Grimes Planning & Zoning Commission Meeting February 6, 2024 In Person at Grimes Community Complex, 410 SE Main Street, Room 202

Tru Hotel Site Plan

RE: Tru Hotel Site Plan

The Development Services Department is in receipt of a proposed Site Plan for the Tru Hotel. Based on the review of the provided submittal materials, staff have the following comments:

UTILITY PLAN

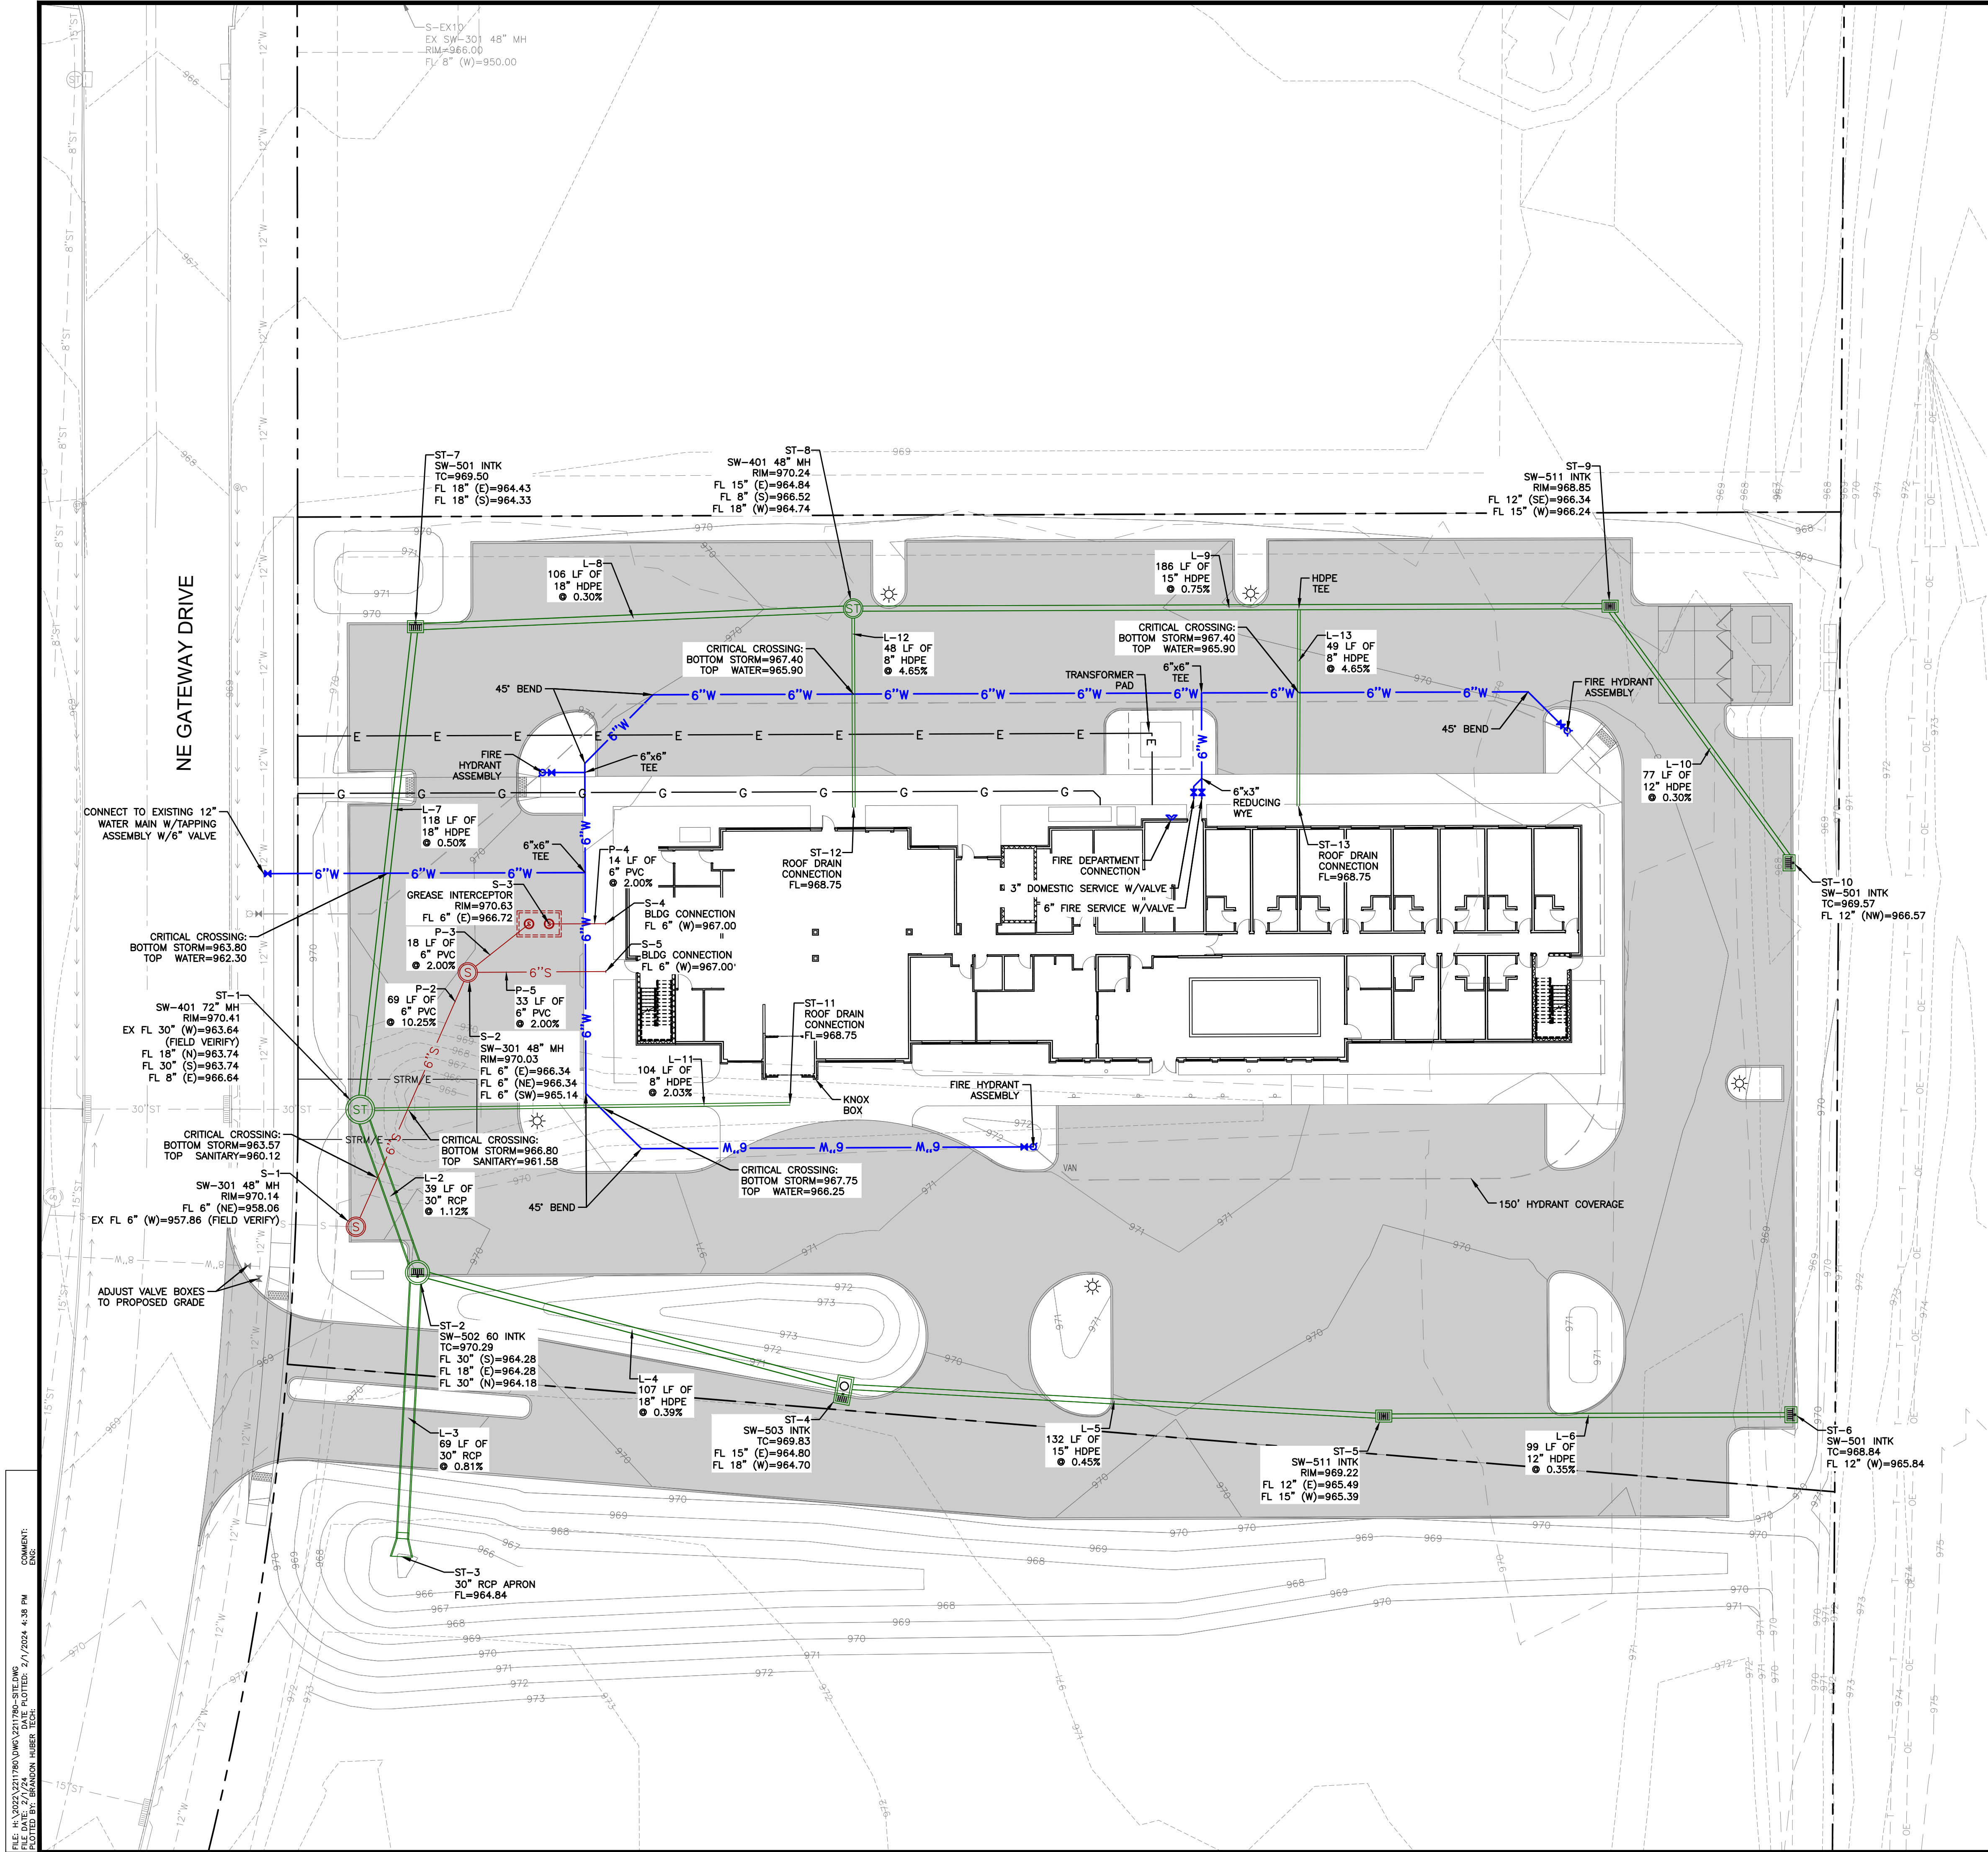
1. ~~Label all critical crossing locations. Label crossing elevations for P-2 and L-2.~~
2. ~~Callout adjustment of valve boxes within the ROW.~~
3. ~~Staff has concerns with the storm manhole in the sidewalk connection from Gateway Dr. It will be difficult to get it to align due to the sidewalk slope and will likely shift through the seasons. In addition, the manhole is halfway through through the sidewalk which will likely cause the sidewalk to break. Staff suggest moving the sidewalk connection south to avoid the storm sewer while still providing connection to the building.~~

1. ~~C5.1: Provide drop within storm sewer structures.~~
2. ~~C5.1: Provide critical crossing labels and elevations.~~

SHEET NUMBER:
L1.1
2211.780

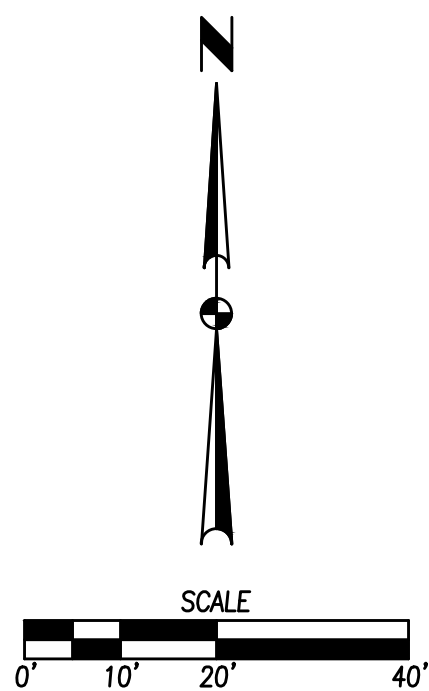
1. ~~Label the ground cover throughout the site. What areas are sod, mulch, rock?~~
2. ~~Revise Landscape Note #5 to note seed or to note sod, not both.~~
3. ~~Staff recommends changing the Colorado Spruce for a different tree. The spruces can get pretty large and will likely block visibility or grow out into the drive aisles.~~
4. ~~Please remove the bush from the parking lot on the north side of the building.~~
5. ~~Staff recommend adding some foundation plantings around the building.~~
6. ~~Please provide shrubs along NE Gateway Drive to provide headlight screening. Staff recommends providing evergreen plantings to provide screening year round.~~

1 WEST ELEVATION
1/8" = 1'-0"

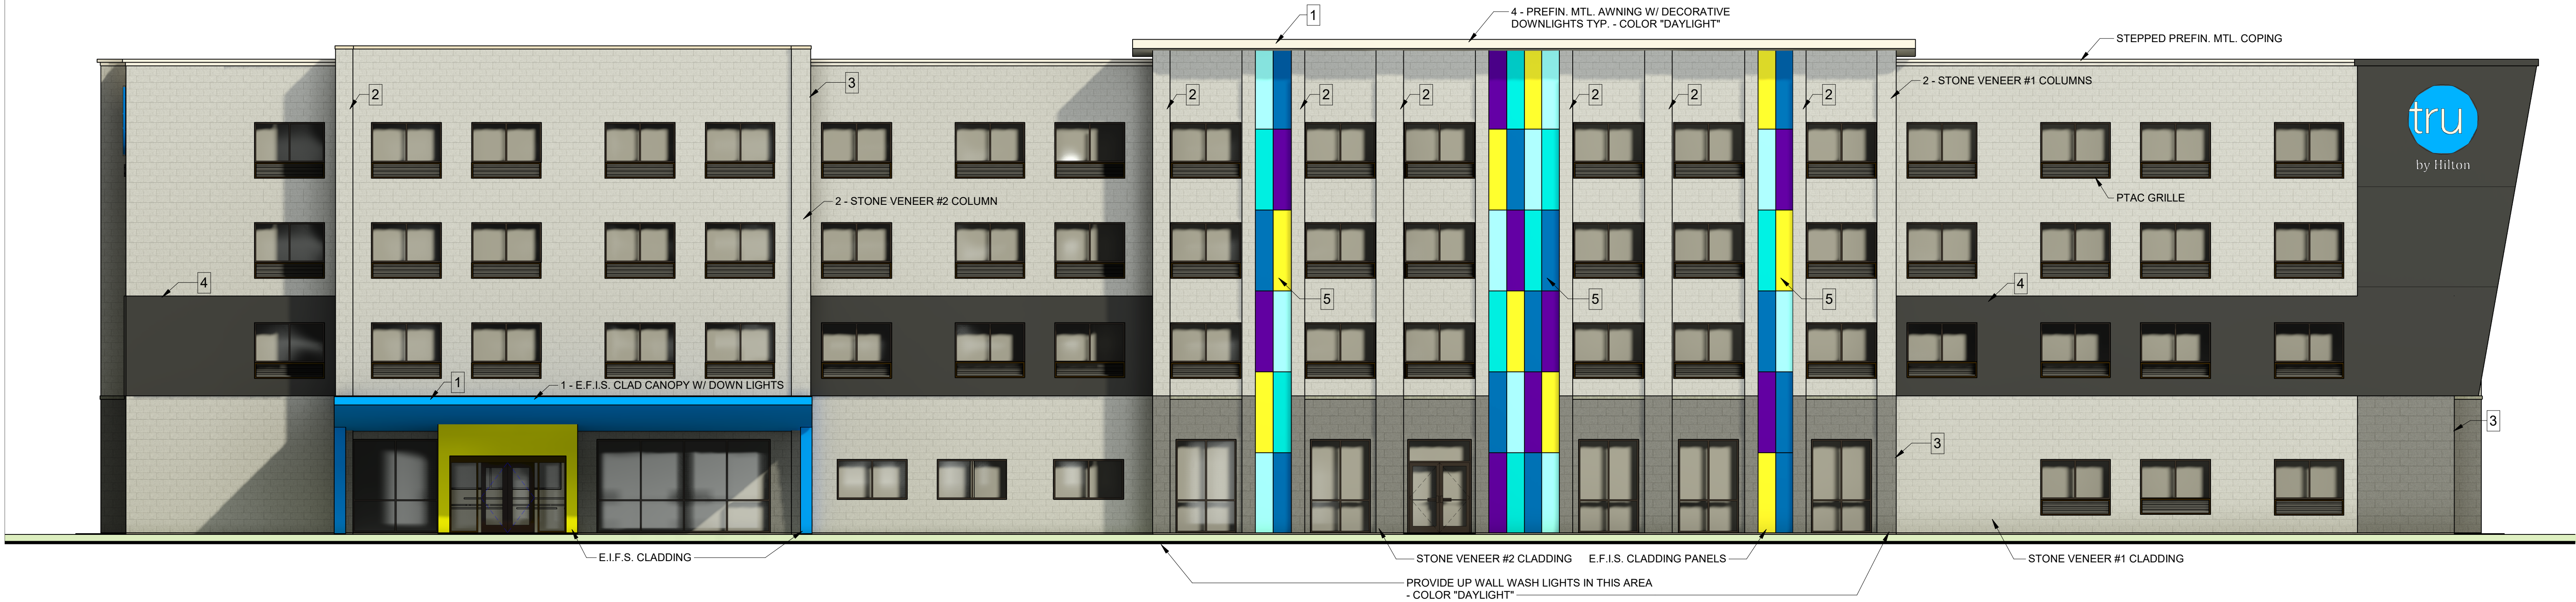
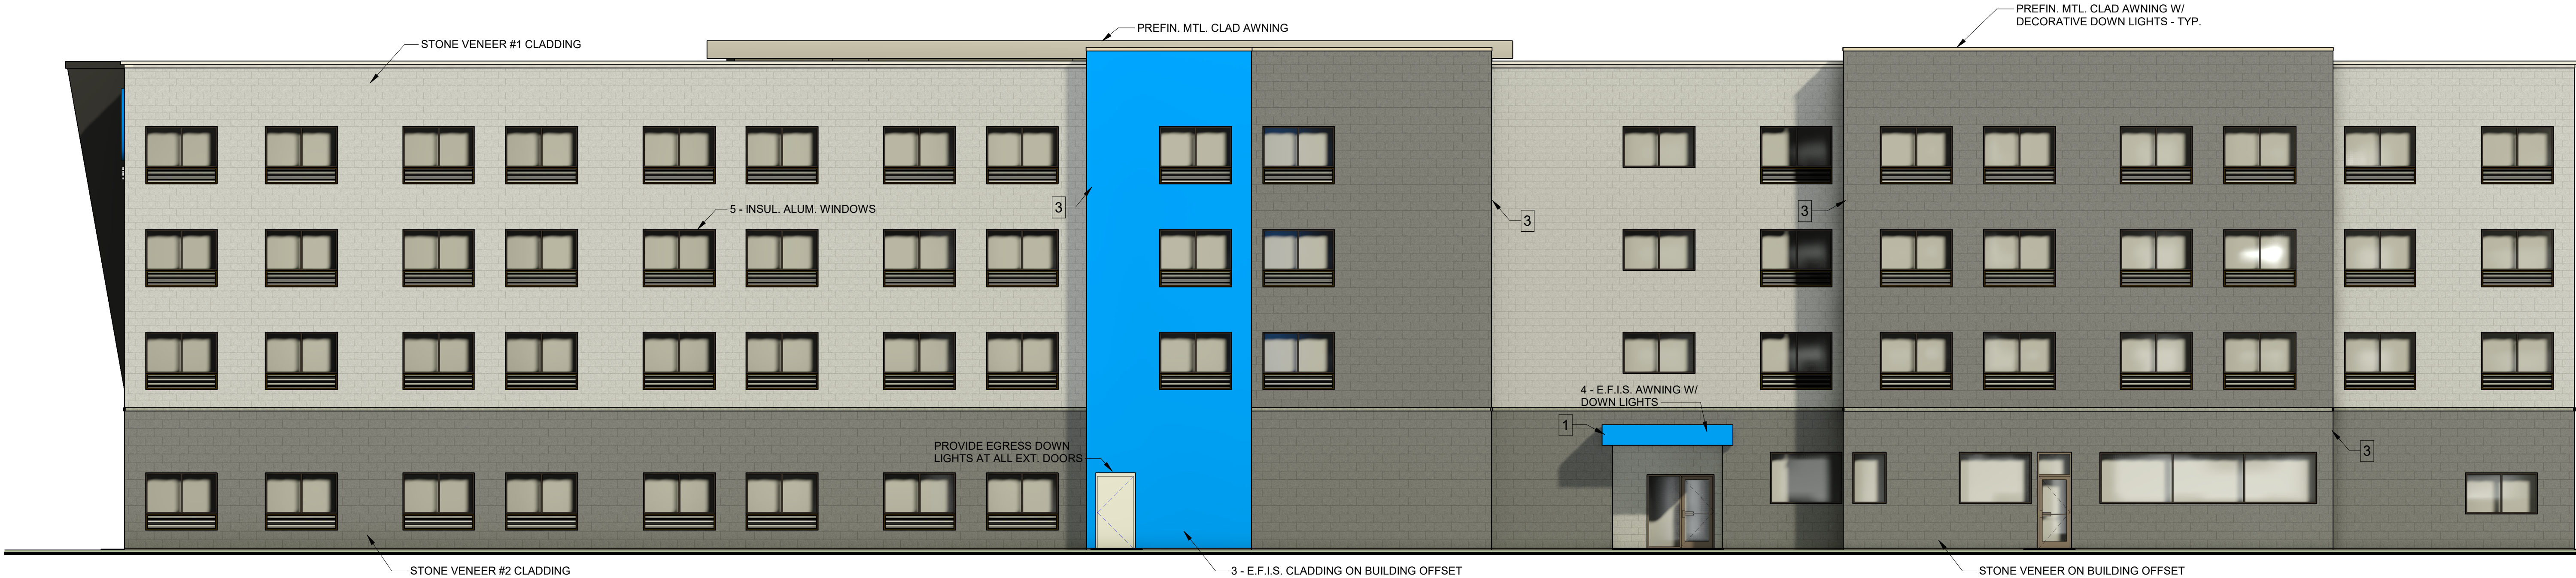
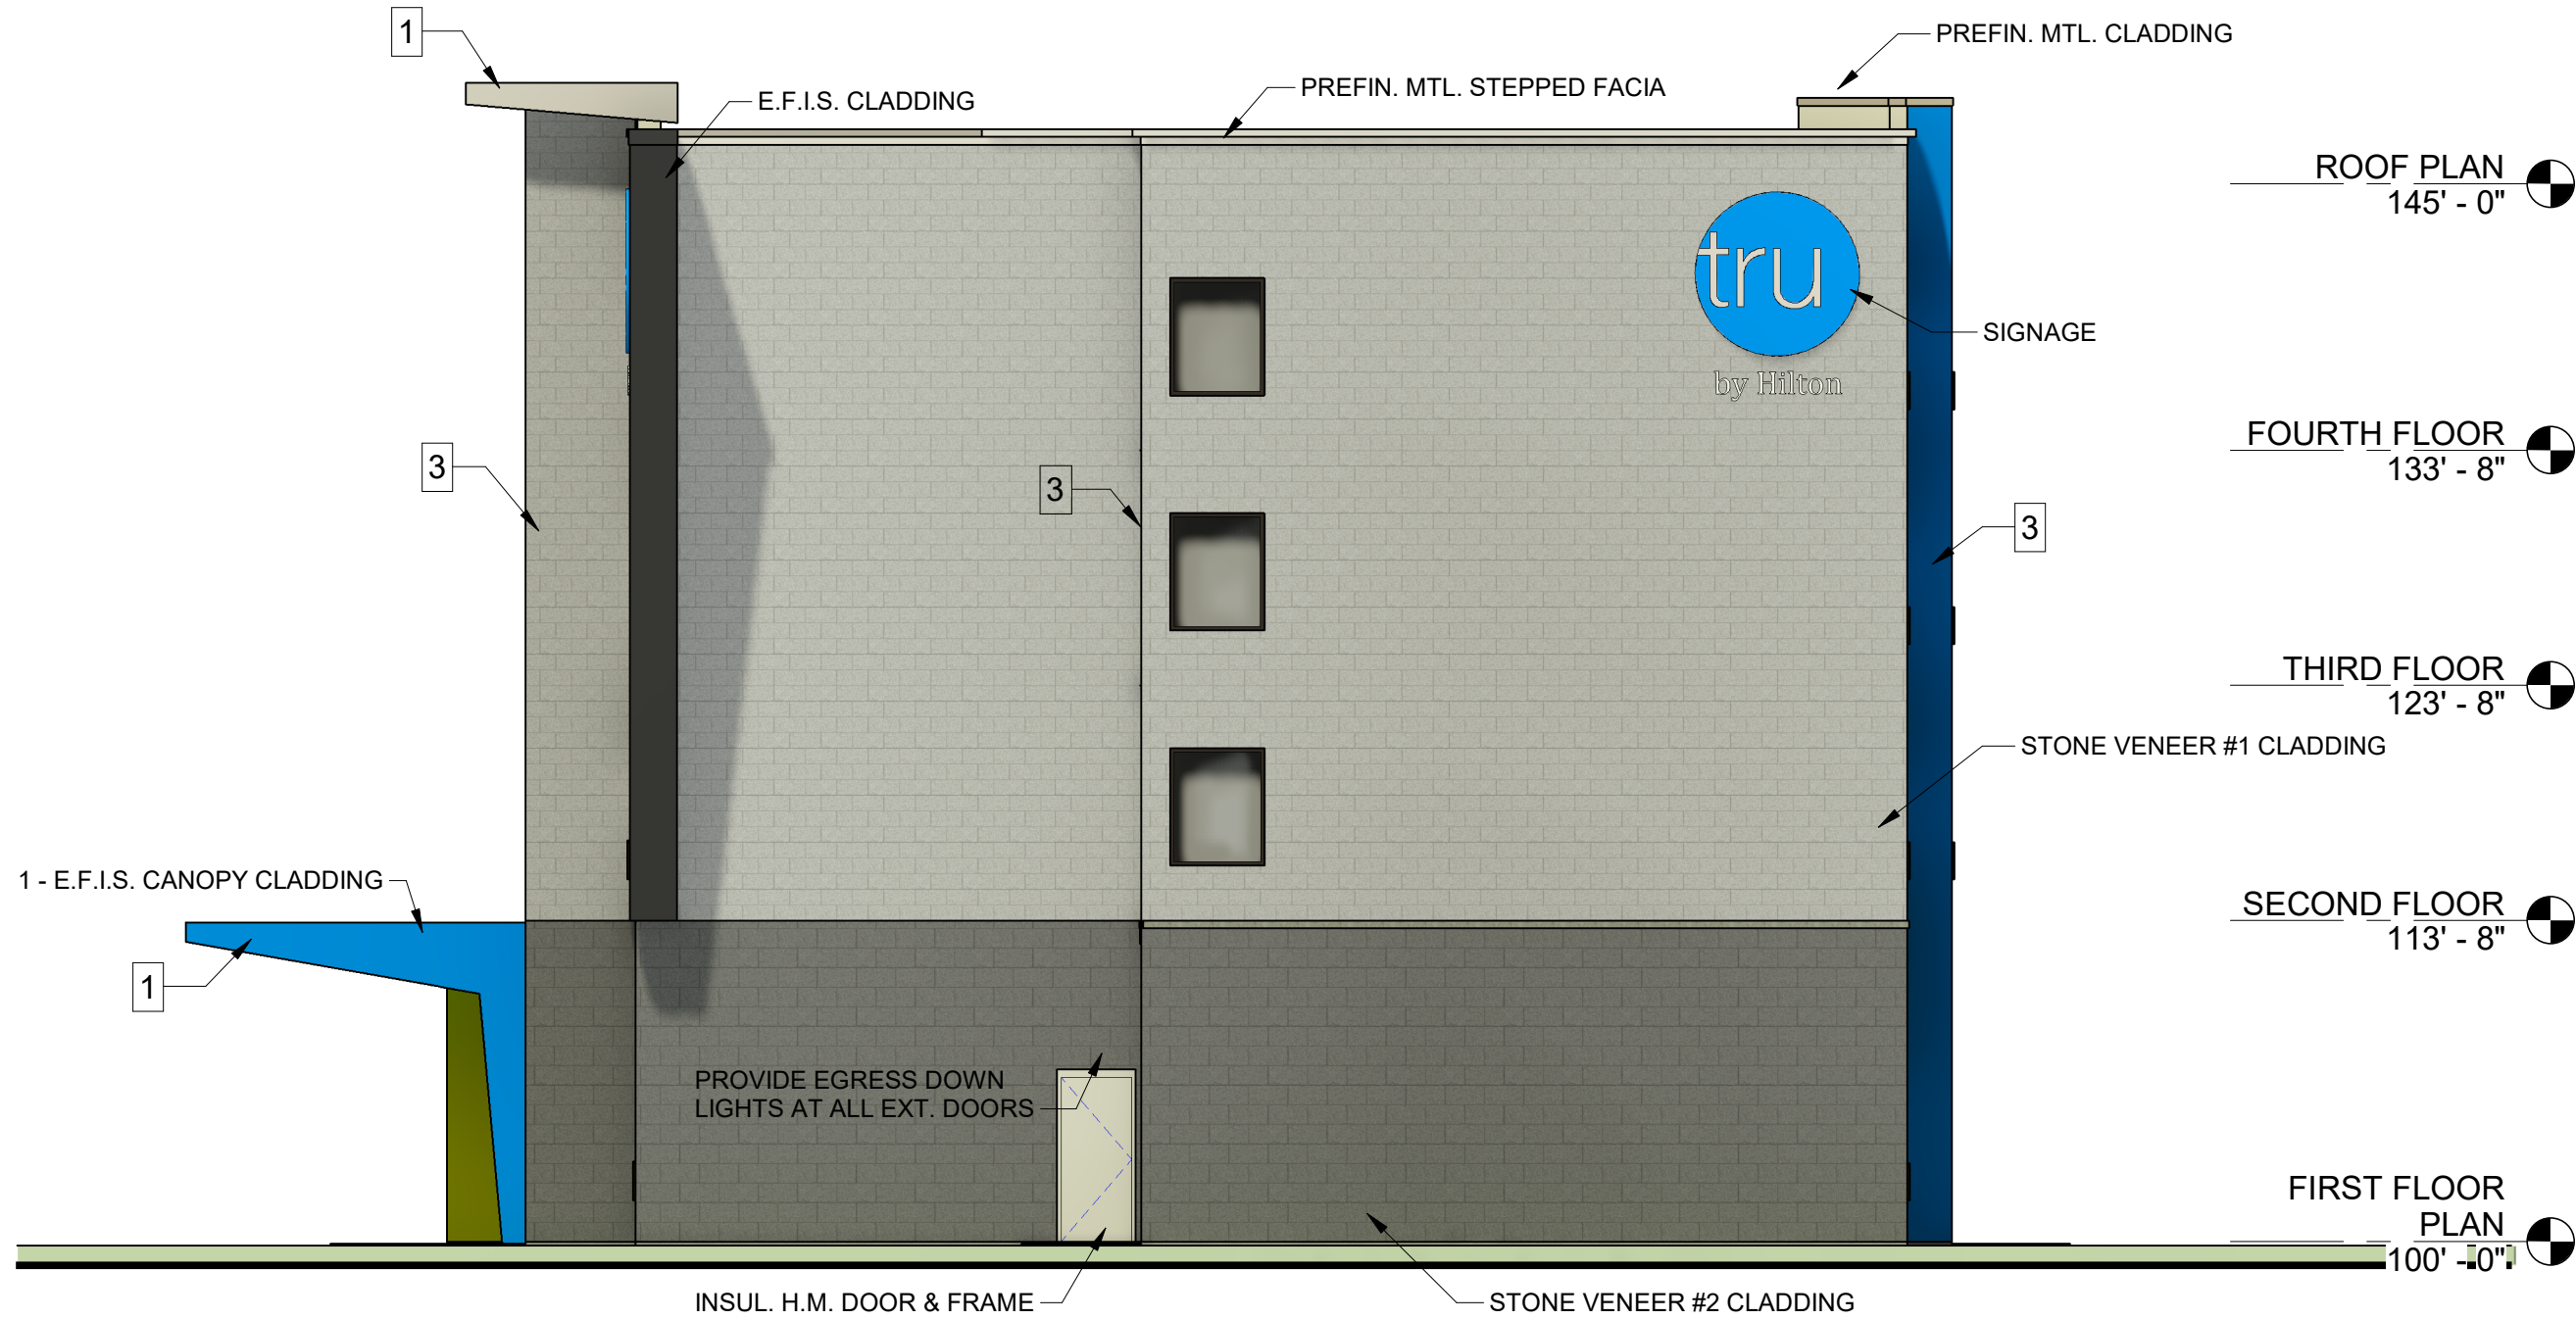
1. ~~Label lighting locations. Is lighting other than emergency lighting proposed on the building? If so, please label locations. What color of lighting is proposed? Will there be any changing colors?~~

2. ~~Provide list/labels demonstrating 5 architectural elements on the building per the list in Section 12-11-1.24.A.1.b. Please update the list to the following:~~

- e. ~~Vertical architectural treatment a minimum of 12 inches in width (colored EIFS on south elevation)~~
3. ~~Revise building materials to provide 75% brick, stone, or masonry on all sides of the building, excluding windows, doors and louvers. EIFS can be provided for up to 25% of the building materials.~~

6. ~~Can some windows be added to the stairway on the east side of the building to help break up the east elevation? Staff would still like to see some windows if possible since the east wall will be visible from Hwy 141 but are pleased with how this building is shaping up.~~

7. ~~Please provide material swatches/photos on the elevation sheets showing the proposed EIFS and stone. What type of stone is proposed? What does the EIFS look like? Where is the Dryvit TerraNeo proposed? Dryvit is not proposed for this building.~~
